# OFFICE OF ENVIRONMENTAL SUSTAINABILITY

INSPECTOR'S REPORT ON AN APPLICATION FOR A CERTIFICATE OF AUTHORISATION FOR A CLOSED LANDFILL					
то:	Dr. Eimear Cotter, Director				
FROM:	Ewa Babiarczyk, Inspector, Environmental Licensing Programme				
DATE:	12 <sup>th</sup> September 2019				
RE:	Application by Limerick City & County Council for a Certificate of Authorisation for a closed landfill at Churchtown, Newcastle West, County Limerick.  Certificate of Authorisation Register Number H0291-01.

Figure 2: Extent of deposited waste

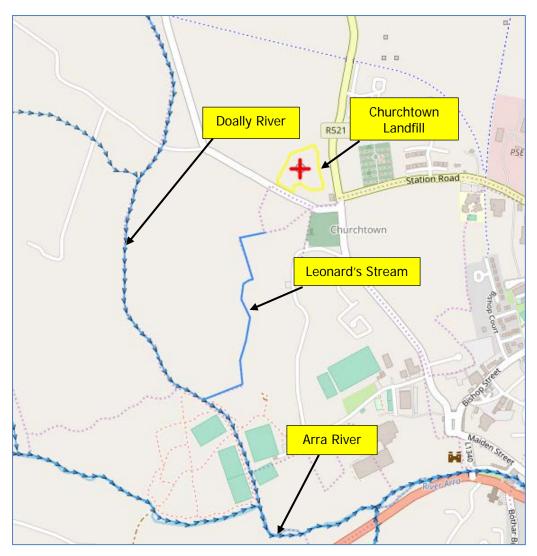
- the waste body extends beyond the northern and eastern site boundaries as shown in Figure 2;
- the existing ground levels vary from 68m to 78m AOD and that thickness of the waste body is 5 to 15m;

Figure 3: Local river network

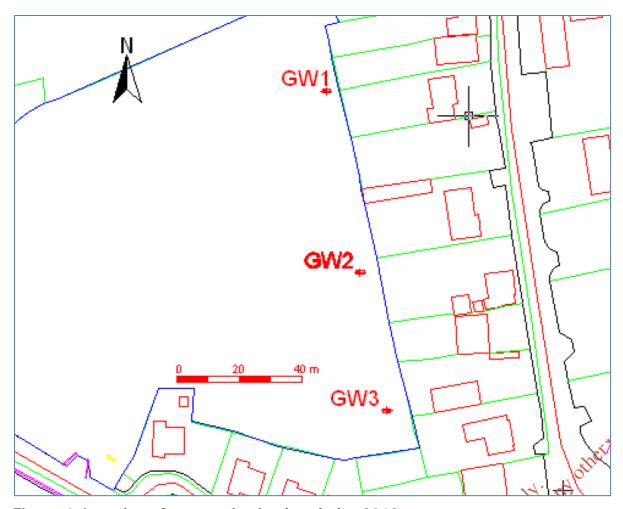
- the landfill is comprised predominately of industrial, domestic, commercial and construction and demolition waste;
- groundwater flow is from the north-east to south-west direction towards the tributary of the Doally River shown in Figure 3. This tributary is referred to by the applicant as Leonard's Stream;

Figure 4: Location of gas monitoring boreholes 2019.

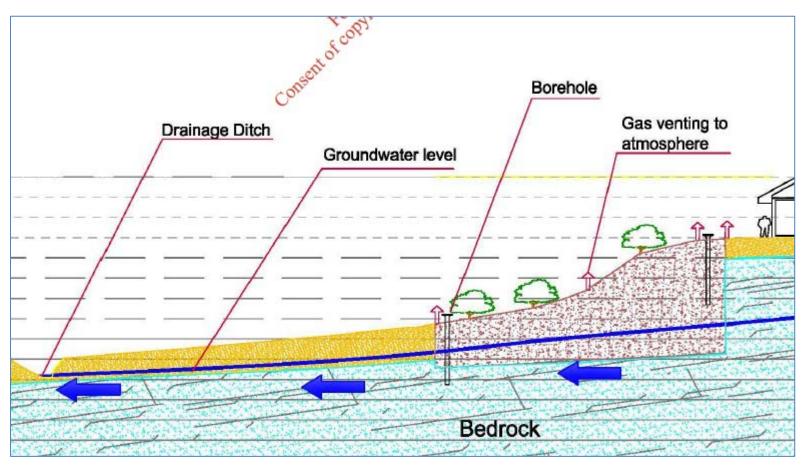
Following the outcome of the model, testing was carried out in 2012. This involved the installation of three gas monitoring wells (GW1 to GW3) as shown in Figure 4. Monitoring results indicated that elevated concentrations of gas were detected in all wells. The monitoring recorded methane levels up to 73.6% in GW3 in the south-east corner of the site, 38.2% in GW2 and 35.7% in GW1.

The most recent landfill gas monitoring was carried out at two out of three monitoring locations GW1 and GW2 on 17<sup>th</sup> June 2019. Methane concentration were recorded at 46.2 % v/v at GW1 and 22 % v/v at GW2. CO<sub>2</sub> was recorded at 27.5 (% v/v) at GW1 and 18.2 % v/v at GW2. The applicant stated that GW3 was inaccessible due to heavy over growth. Condition 3.15 requires that all sampling and monitoring points have safe and permanent access and are clearly labelled.
